**AGENDA
CITY OF CEDAR FALLS, IOWA
PLANNING AND ZONING COMMISSION MEETING
WEDNESDAY, AUGUST 28, 2019
5:30 PM AT CITY HALL**

TO: Planning and Zoning Commission
FROM: David Sturch, Planner III
DATE: August 21, 2019
SUBJECT: Land Use Map Amendment

TO: Planning and Zoning Commission
FROM: Iris Lehmann, AICP, Planner II
DATE: August 22, 2019
SUBJECT: Façade review of property in the Central Business District Overlay

TO: Planning & Zoning Commission
FROM: Iris Lehmann, ACIP, Planner II
Matt Tolan, Civil Engineer II
DATE: August 22, 2019
SUBJECT: Panther West Preliminary Plat

Existing Land Use

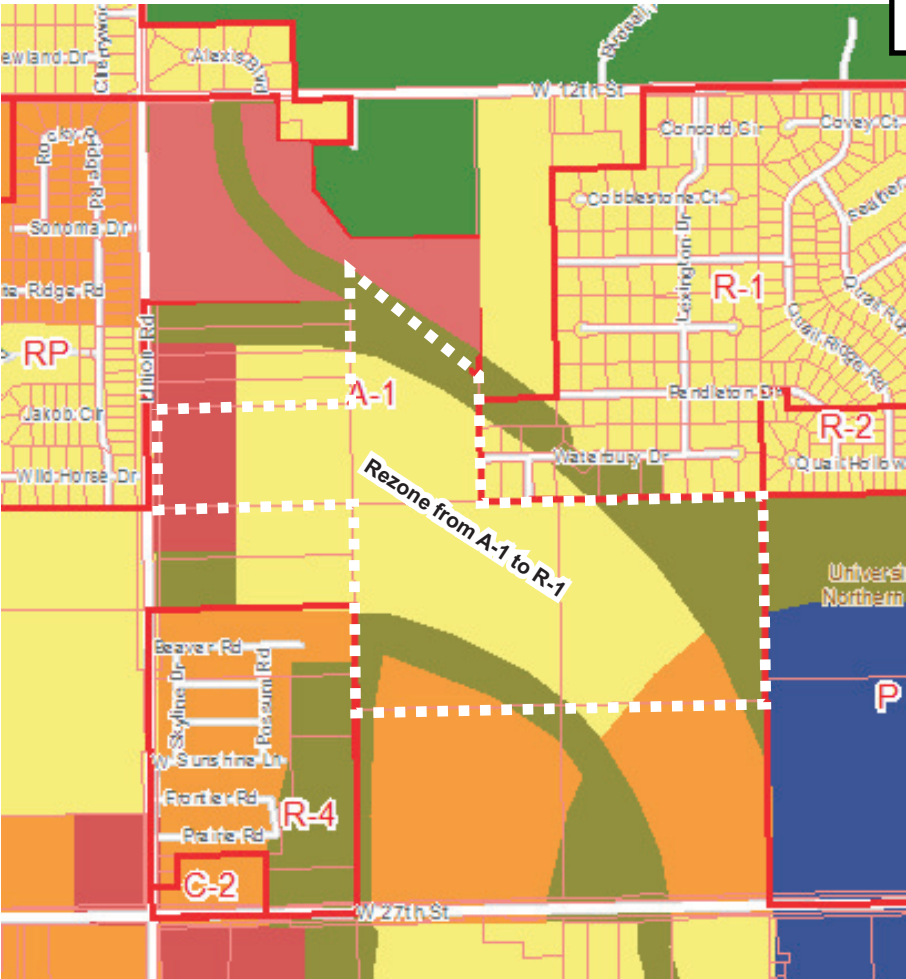
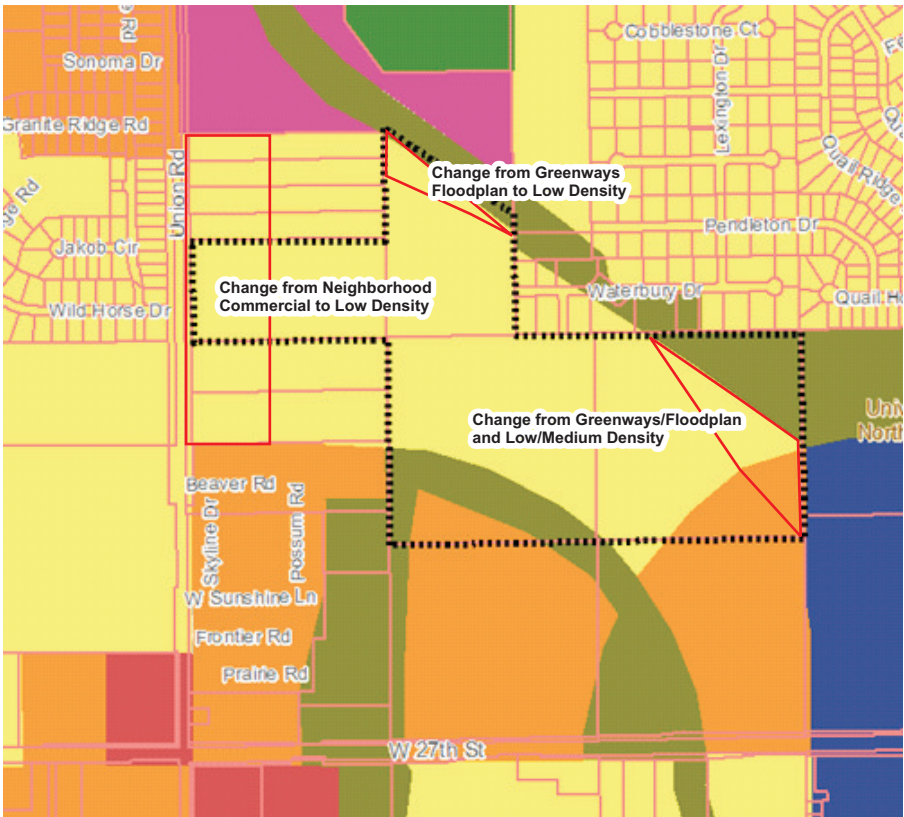
Generally speaking, the future land use for this area is low density residential. However, there is a section of land along the east side of Union Road that shows a neighborhood commercial/mixed use designation and a strip of greenways/floodplain along the University Branch of Dry Run Creek. Therefore, the land use analysis is the first step in the rezoning and development process.

The neighborhood commercial/mixed use category is identified in the Comprehensive Plan as low impact commercial with residential in the upper floors located on major streets, or in this case, Union Road. There are other neighborhood commercial land use areas at major intersections to the north and south of this site. Staff feels that maintaining this commercial land use at major intersections is more appropriate, since zoning too much land for commercial development, particularly in areas on the edge of the community in lower density areas, dilutes the market and reduces the viability of all of the nearby commercial areas as they compete against one another for market share. Therefore, staff recommends changing this commercial designation to low density residential.

The Community Development Department recommends approval of an amendment to the Future Land Use Map from Greenways/Floodplain and Neighborhood Commercial to Low Density Residential subject to the following conditions:

Current

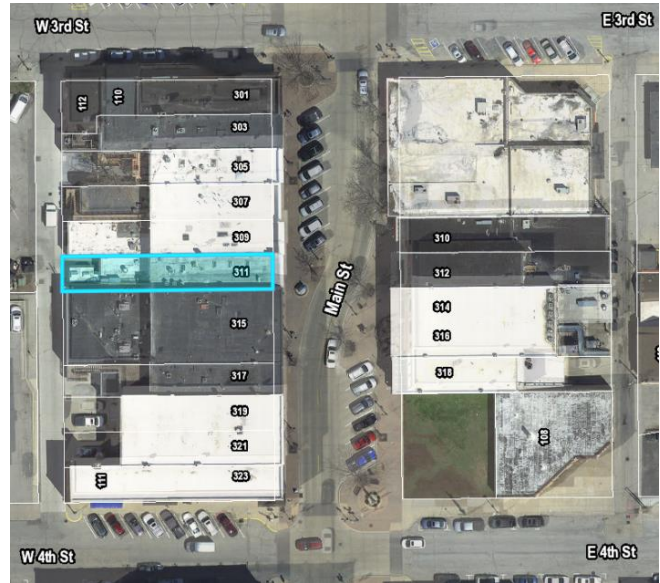
The current façade has three large, well-proportioned storefront display windows separated by two vertical mullions that correspond to the architectural design of the paneled knee wall. The applicant is proposing to replace the windows on the storefront with two glass garage doors. See sample image of the proposed door to the right. To do this the applicant is proposing to remove the three large display windows and the two vertical mullions that currently separate the windows on the storefront and install a new vertical mullion in the center of the opening. The knee wall would remain as is. Staff understands how operable windows would be an attractive feature for a restaurant during the summer months. However, one of the most important aspects of storefront design is the large display windows. Large display windows are ideal for allowing unimpeded views into the interior of the store, which works well for all types of retail and restaurant uses. Changing out the classic storefront window configuration by replacing the display windows and mullions with modern industrial garage doors would be a substantial change that is not in keeping with the historic character of the building or district and may make this storefront space less

attractive for any use other than a restaurant or bar. The proportion of the garage door openings do not fit into the existing proportions of this façade and will not align with the panels on the knee wall. There are other types of storefront operable windows that slide or swivel open, but when closed maintain the large expanse of glass typical of a storefront display window. While this storefront has been modified over time, it still includes the classic elements of traditional storefront design. Staff has encouraged the applicant to explore other options that would achieve his goals for an indoor/outdoor restaurant space but in a manner that would be more in keeping with the existing architecture of the building. **Criterion not met with the proposed garage door.**

2. Roof shape, pitch and direction: As the building's roof is not being altered, **this criterion does not apply for this review.**
3. Pattern: The pattern of solid surfaces and openings needs to be considered in the alteration of a building. The applicant is proposing to remove the two vertical mullions from the storefront and add a new one in the center of the opening. Although the proposed garage door does have glass lites, the metal that surrounds the glass is substantially wider than what would be typical for window muntins, and creates much smaller openings that are not consistent with the traditional architecture of this building. This pattern is not consistent with the historical character of this building or the pattern of solid surfaces and openings of the traditional storefronts along Main Street. **Criterion not met.**

4. Building Composition: the overall structure of the building will not change; **this criterion does not apply for this review.**
5. Windows and transparencies: Although the proposed garage door does have glass lites, the many new solid breaks in the proposed garage doors make the structure less transparent than the existing design. According to the zoning code requirements, a minimum of 70 percent of the storefront area between two and ten feet in height above the adjacent ground level must consist of clear and transparent storefront windows and doors that allow views into the interior of the store. The current storefront appears to be right at the required percentage of glass. Reducing window coverage on a storefront is highly discouraged. **Criterion not met.**

8. Architectural features: The current façade has three large, well-proportioned storefront display windows separated by two vertical mullions that correspond to the architectural design of the paneled knee wall and the traditional design and function of the building. Changing out the classic storefront window configuration by replacing the display windows and mullions with modern industrial garage doors would be a substantial change that is not in keeping with the architecture of this traditional mainstreet storefront building. Staff is not opposed to use of glass garage doors in general. They may be very attractive features if used on a commercial or manufacturing building that is being repurposed as a restaurant or store or along the side of a building that was not originally configured as a storefront. There are a number of buildings and facades in the downtown area that fit this description. However, in this particular case, the proposed garage doors do not contribute to the existing architectural features of this building and are out of character with the classic storefront buildings along Main Street. **Criterion not met.**

The Community Development Department recommends denial of the submitted proposal to replace the storefront windows with glass garage doors on the building at 311 Main Street. Staff recommends approval of the awning with the following stipulations:

Example of proposed awning

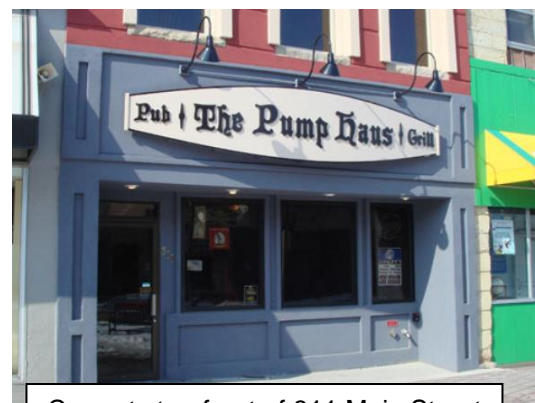
1. Proportion: The applicant is proposing to install a 20 foot by 10 foot retractable awning. The awning will be mounted on the building 10 feet above the sidewalk level and will extend 10 feet over the sidewalk to cover most of the sidewalk café. The edge of the sidewalk café, see attached plan, is angled to follow the street curve. At the point of full extension the awning will have a clearance of 8 feet off of the sidewalk (meeting the minimum clearance

requirements). See sample image on the previous page. The awning adds a new horizontal element to this façade. Awnings are common in the downtown but not at this scale. It is standard practice that any projection over the public right-of-way is limited to 5 feet or half the width of the sidewalk in front of the building, whichever is less. However, this is the first time an awning has been proposed in relation to a sidewalk café. The proposed awning would be in proportion to the sidewalk cafe and will not extend over the remaining walkway. The purpose of an awning is to provide shade and weather protection and historically large retractable awnings were commonplace features of a storefront. Staff is of the opinion that this type of improvement could be appropriate as long as the awning is retracted or taken down when the sidewalk café is removed. In addition, to ensure public safety, any projections over the right-of-way must be reviewed and approved by the Building Official to ensure that they are mounted properly and are designed in a manner that can withstand expected wind loads. As this is the first awning of its type proposed in the district, a discussion from the Commission is warranted. **Discussion needed.**
